**RE: 23-43 & 45 TATTERSALL ROAD, KINGS PARK
RESPONSE TO SUBMISSIONS**

As requested, please find herein The Transport Planning Partnership's (TTPP) response to submissions from the Department of Planning, Industry and Environment (DPIE) relating to traffic matters in relation to the State Significant Development (SSD-10396).

Traffic Item 1 (DPIE Item 6)

Figure 3: Amended On-site Stacking Plan

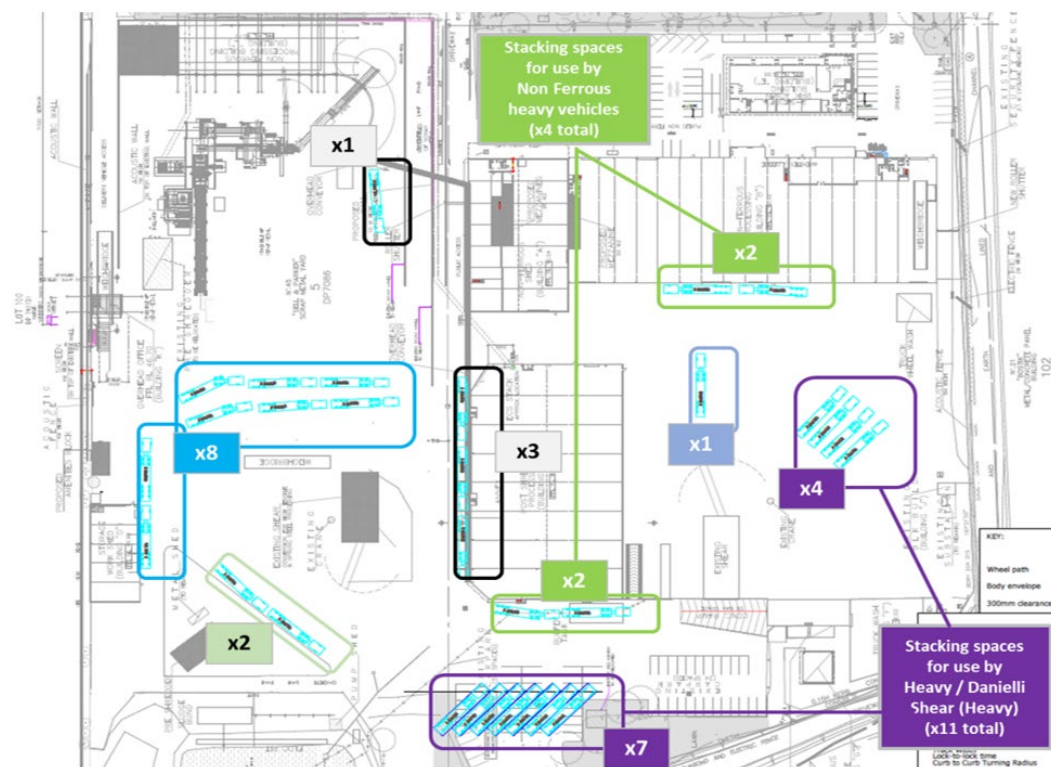
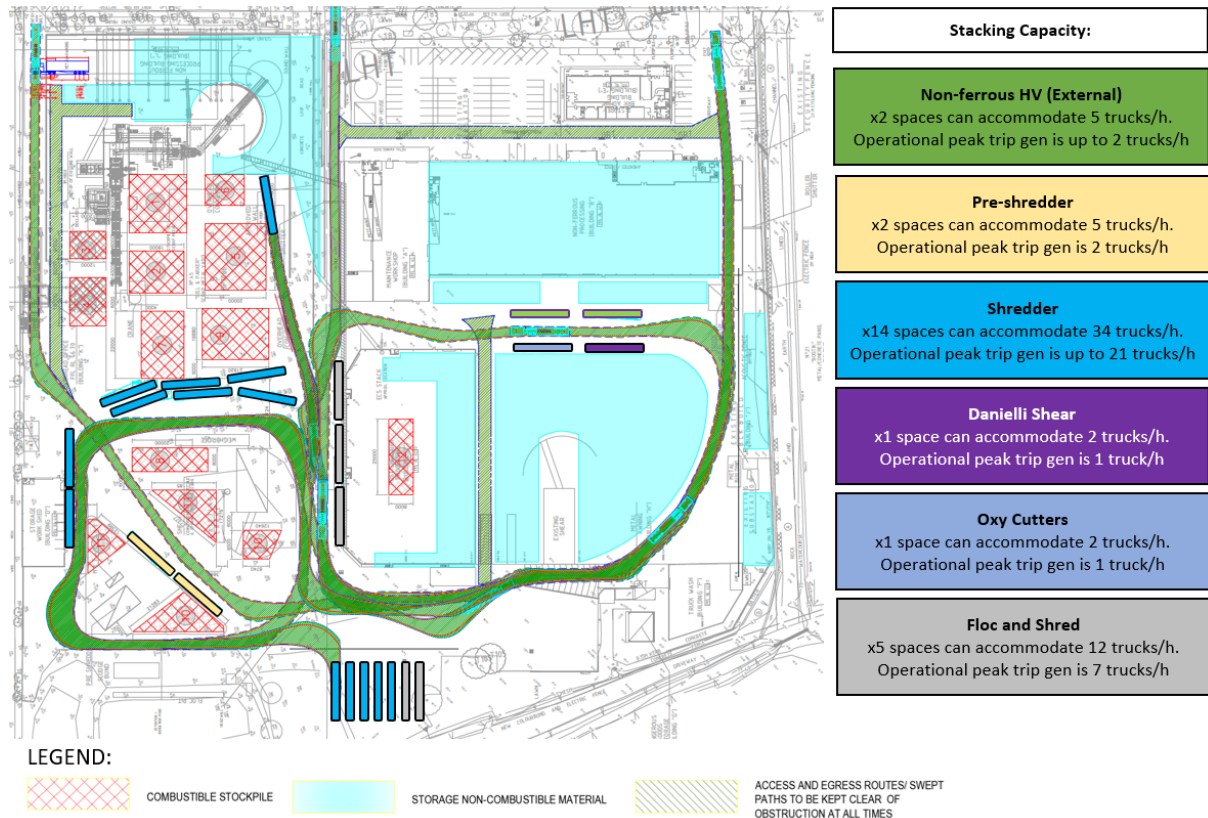
6. It would appear that Figure 6-1 in the Traffic Assessment (Appendix E of the EIS) shows heavy vehicles queuing/stacking in areas shown as stockpiles in the SP (Appendix G of the RTS). Please provide an amended Figure 6-1 that includes the proposed stockpile layouts and demonstrates there is sufficient room onsite for vehicle queueing.

The stockpile plan and vehicle stacking plan have been updated, ensuring that vehicles can manoeuvre through the site or be waiting in a stacking area without impeding stockpile access and site operations. The revised onsite staking plan has been provided in Attachment One.

As presented in the TIA, on-site vehicle stacking capacity has been assessed across the various processing areas on-site for each type of material. Previously, the number of available stacking spaces as assessed in the TIA were as per Figure 2 and Table 2. However, the vehicle stacking plan has since been amended for enhanced manoeuvrability and stacking through the future site. The amended stacking plan and on-site stacking analysis are presented in Figure 3 and Table 3.
